Application for Planning Approval

DA2025/041

MULTIPLE DWELLINGS X 2 (NDIS HIGH PHYSICAL SUPPORT HOUSING)

FURTHER INFORMATION RESPONSE AND CHANGES TO THE PROPOSAL - 20 ARBIE LANE, OLD BEACH

DRAWING
 SITE PLAN

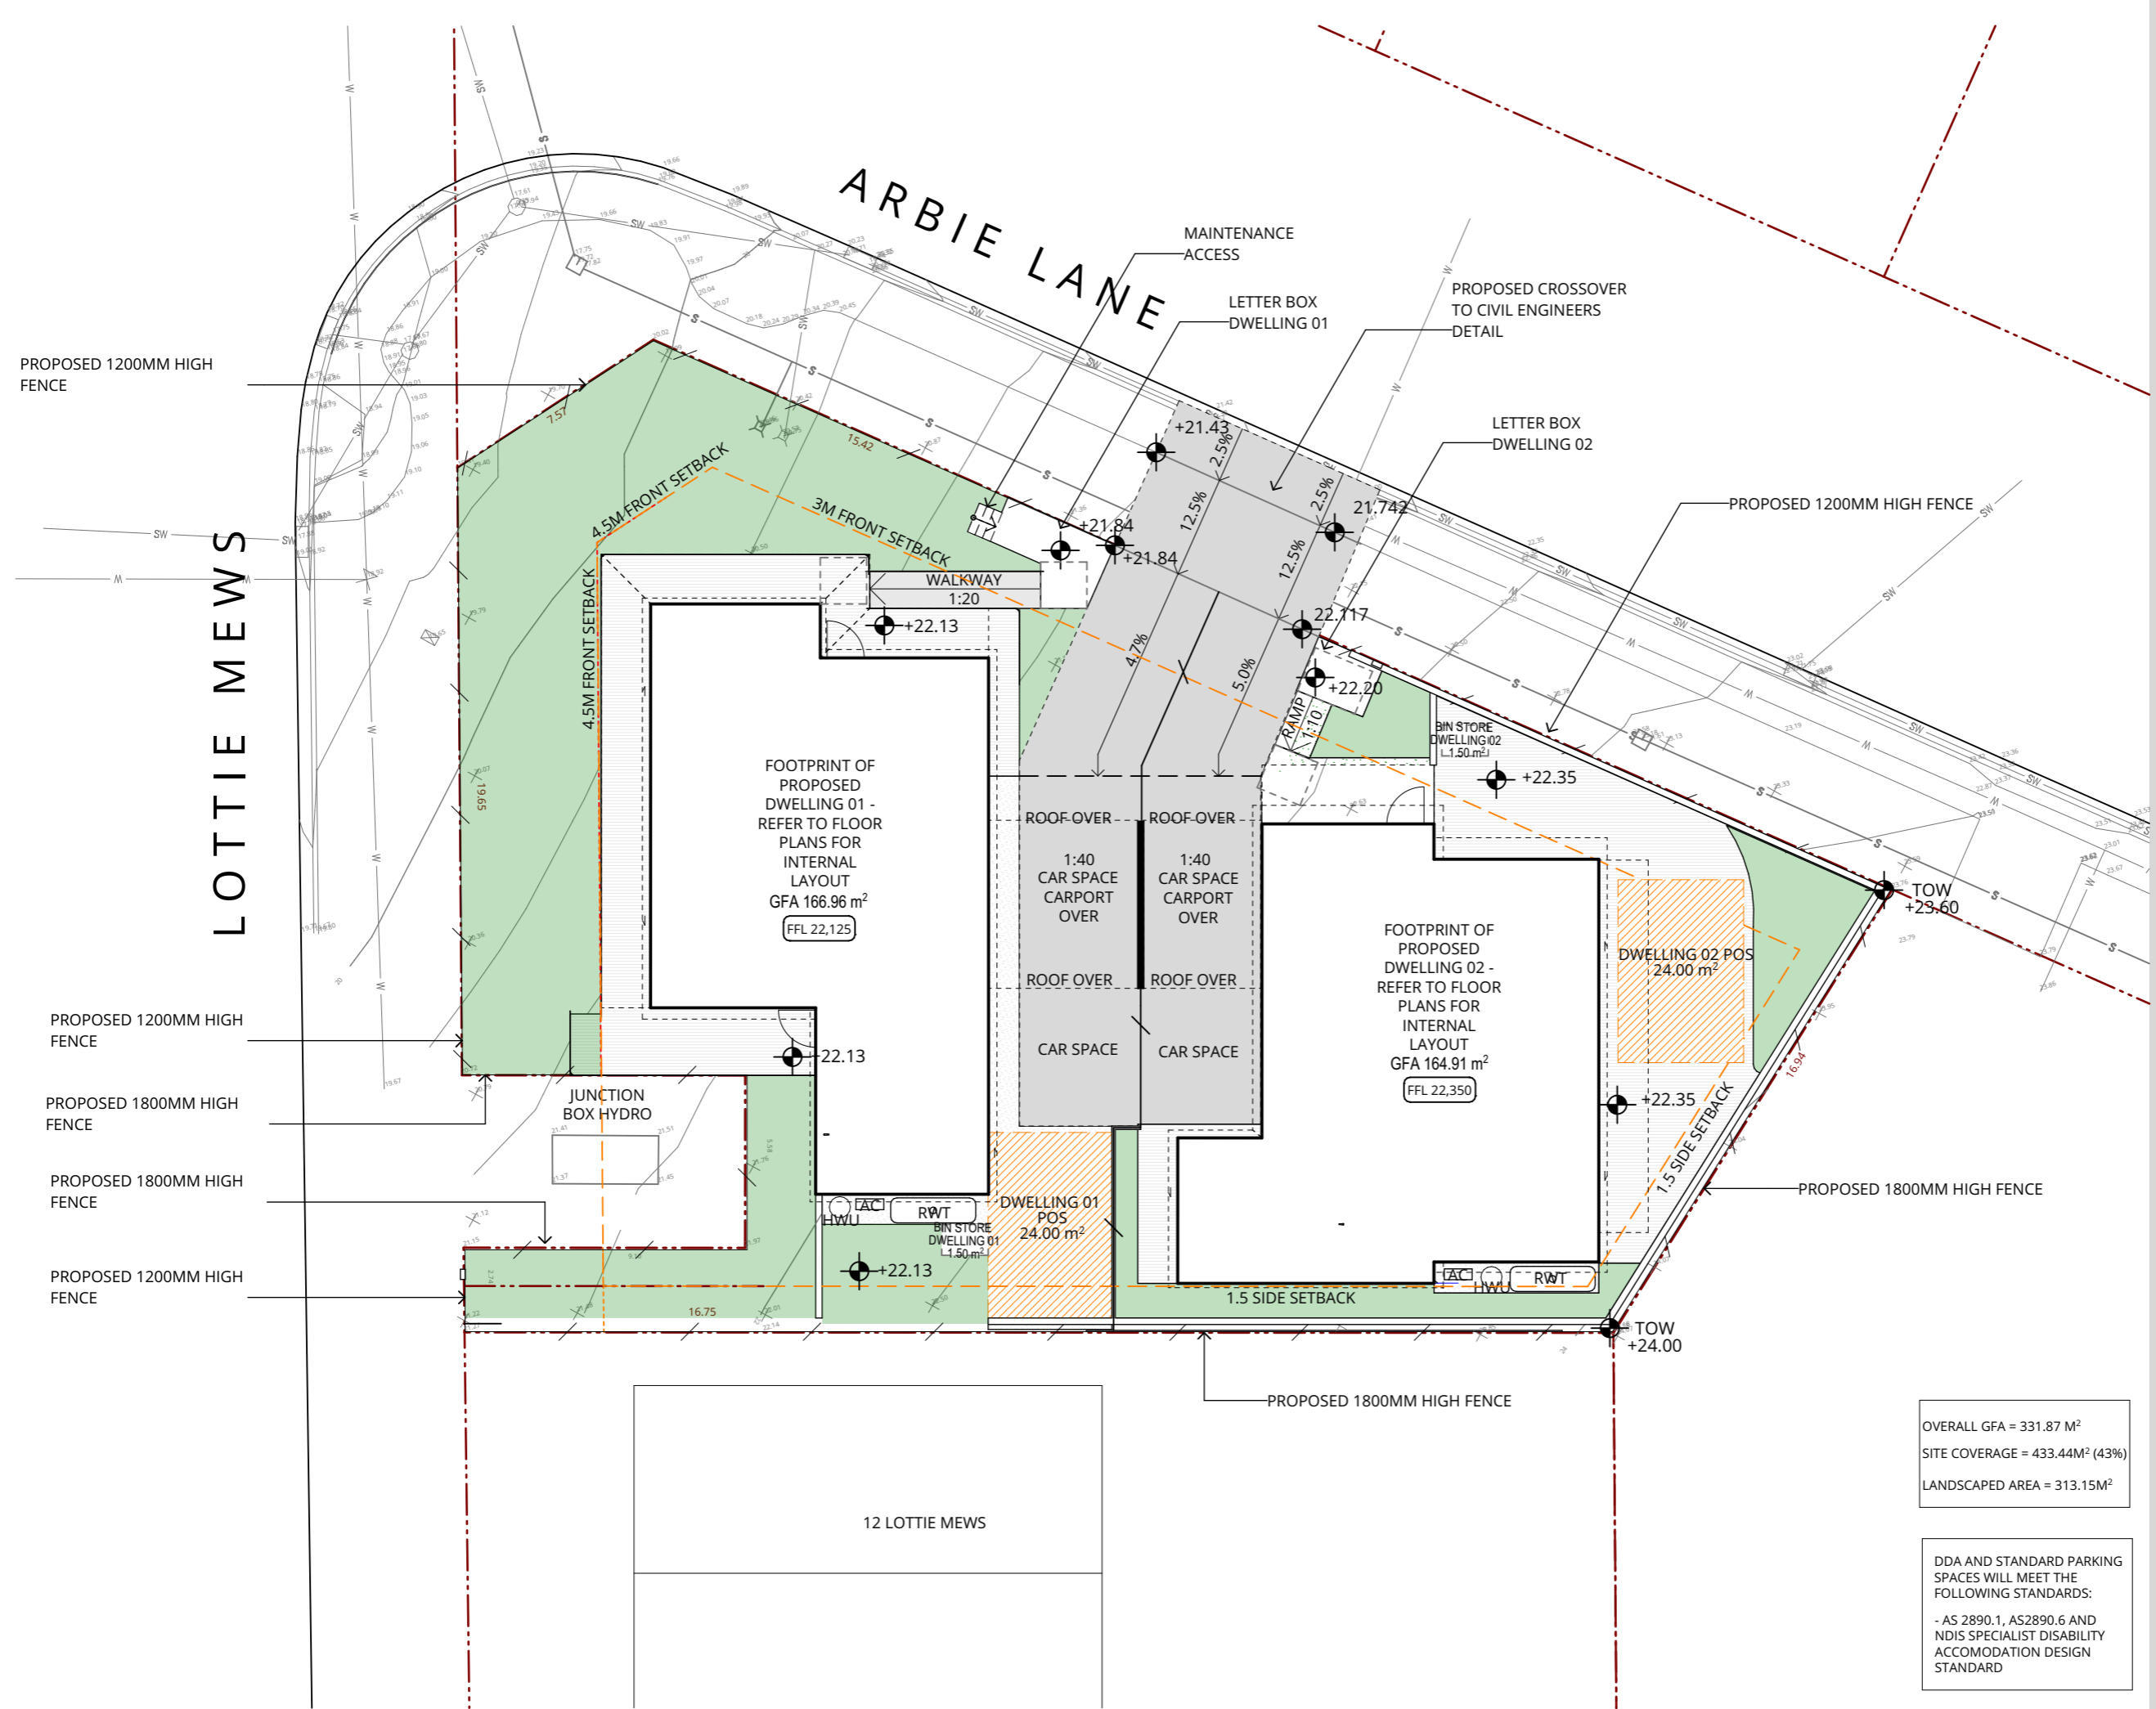
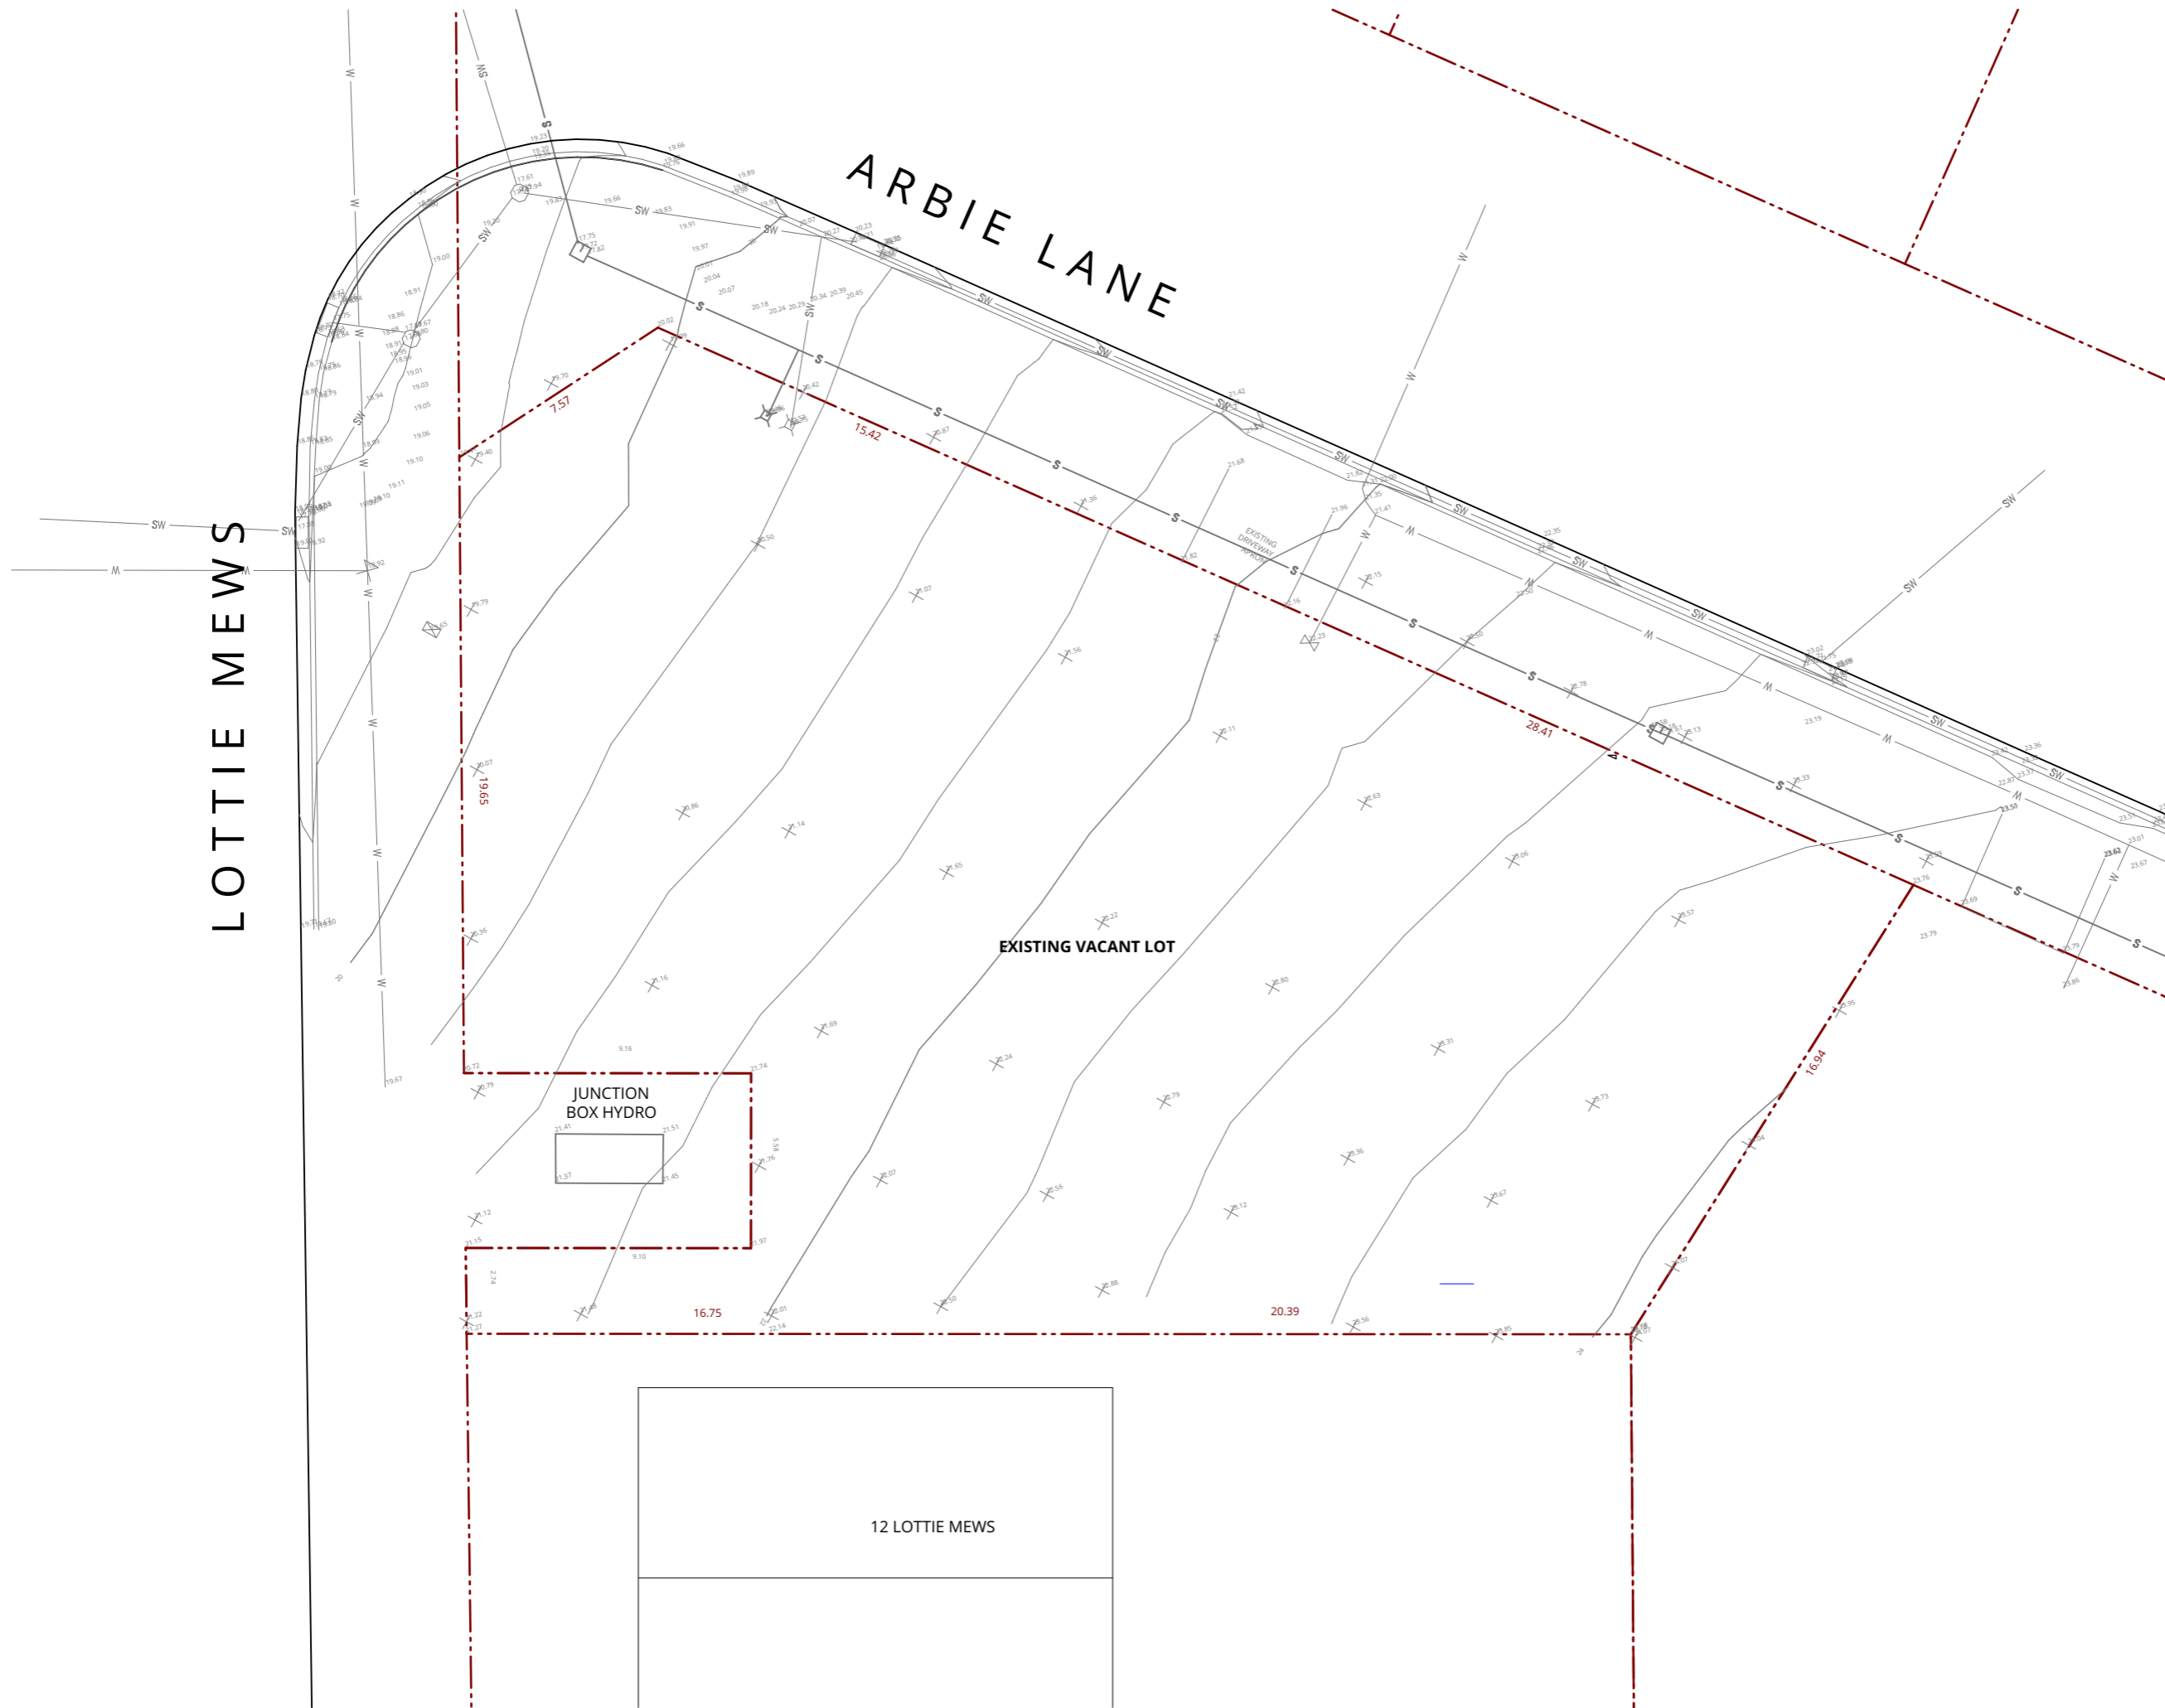
Consequently, it is also proposed to replace the previously proposed steps at the frontage with a ramp to provide an access from the driveway to the dwelling, which will be clear of the OSD tank. It is also noted that this access dwelling 01 is in addition to the access already provided from the eastern side of the dwelling. To ensure continued access to the front yard, a small set of steps from the letterbox access is also proposed, which will also be clear of the revised OSD tank location.

This revision has been incorporated into the revised Proposal Plans prepared by Space Design Architecture (SDA) (20 October 2025 - Issue F) which have been provided with this response. It is intended that this package of proposal plans replace the package previously submitted to council as part of previous responses to further information requests, noting that the only change in this package relates to the amendments which provide for the revised ramp/steps access.
